UNITED STATES PATENT AND TRADEMARK OFFICE

| APPLICATION NO. | FILING DATE | FIRST NAMED INVENTOR | ATTORNEY DOCKET NO. | CONFIRMATION NO. |
|-----------------|-------------|----------------------|---------------------|------------------|
| 10/606,200 | 06/25/2003 | Missoum Moumene | 101896-175 | 4354 |

| Office Action Summary | Application No. 10/606,200 | Applicant(s) MOUMENE ET AL. | |

DETAILED ACTION

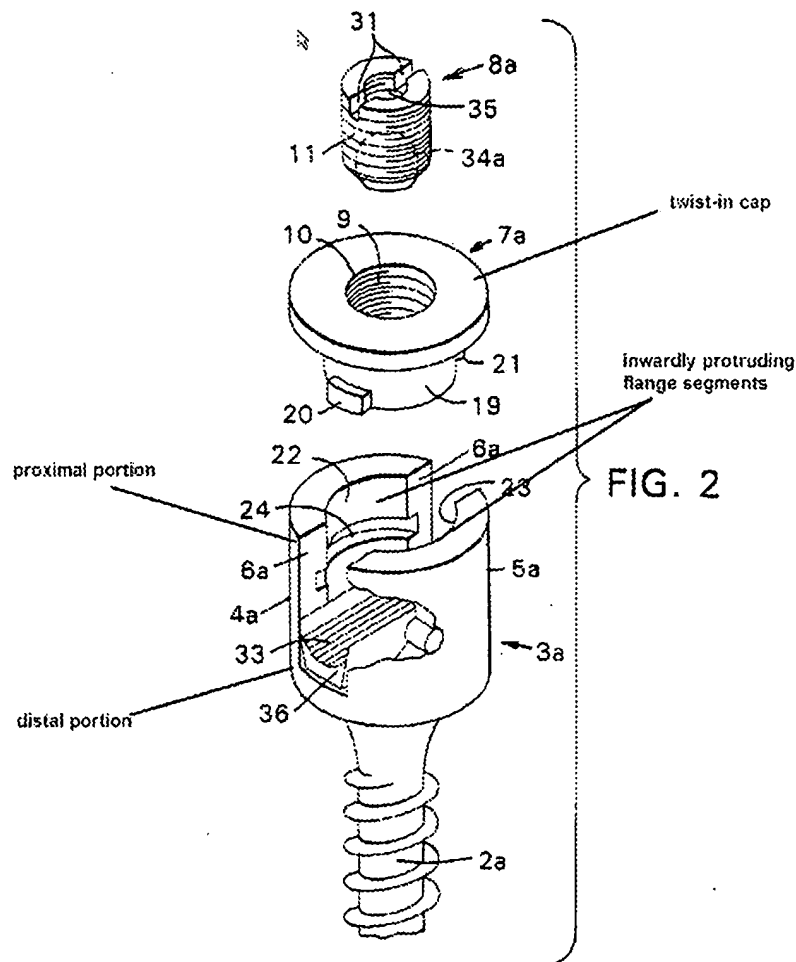
Claim 1 is rejected under 35 U.S.C. 102(e) as being anticipated by Schlapfer et al. (U.S. Patent No. 6,077,262, cited by applicant).

Schlapfer et al. disclose a spinal anchor assembly comprising an anchor element, e.g. 3a, having a proximal portion including an open slot and radially inwardly protruding flange segments (see Figure 2 below). The assembly further includes a twist-in cap, e.g. 7a. The proximal portion and the cap have the ability to twist lock together by a partial rotation of the cap.

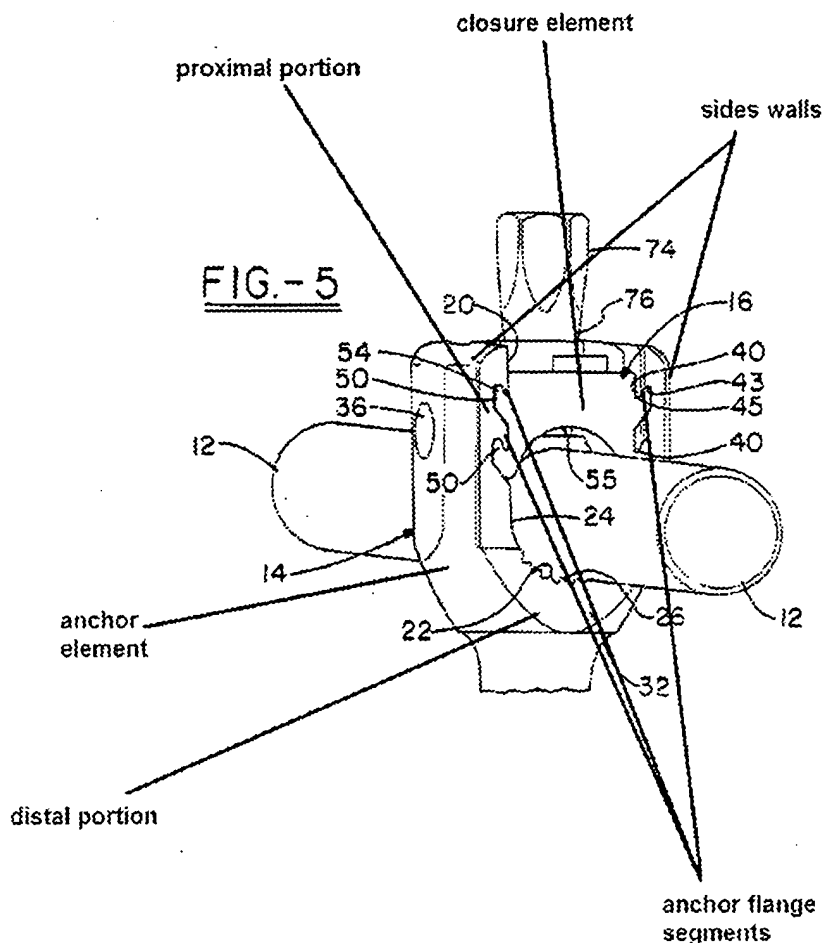
Claims 28 and 31 are rejected under 35 U.S.C. 102(e) as being anticipated by Mellinger et al. (U.S. Patent No. 6,302,888, cited by applicant).

Mellinger et al. disclose an anchor assembly comprising an anchor element, e.g. 14 or 14' (see Figures 5-7). The anchor element defines a central longitudinal axis and having an open slot, side walls on opposed sides of the open slot, a proximal portion, a distal portion, and an anchor flange segment extending from each of the side walls in a direction toward the central longitudinal axis (see for example Figure 5 below).

The anchor flange segments each includes an inferior contact surface (see Figure 5 above) extending in a direction toward the central longitudinal axis and toward the distal portion defining a radial slant. The assembly further includes a closure element (see Figure 5 above) including a closure body and a plurality of closure flange segments extending from the closure body in a direction that is transverse to the anchor element central longitudinal axis (see Figure 5 above). Each of the closure flange segments includes a superior contact surface extending in a direction away from the central longitudinal axis and toward the proximal portion of the anchor

element at the radial slant. The radial slant are configured to permit sliding of the anchor flange segments with respect to the closure flange segments.

Mellinger et al. disclose the claimed invention except for the radial slant being at an angle of approximately 45 degrees to the central longitudinal axis. It would have been obvious to one having ordinary skill in the art at the time the invention was made to construct the assembly of
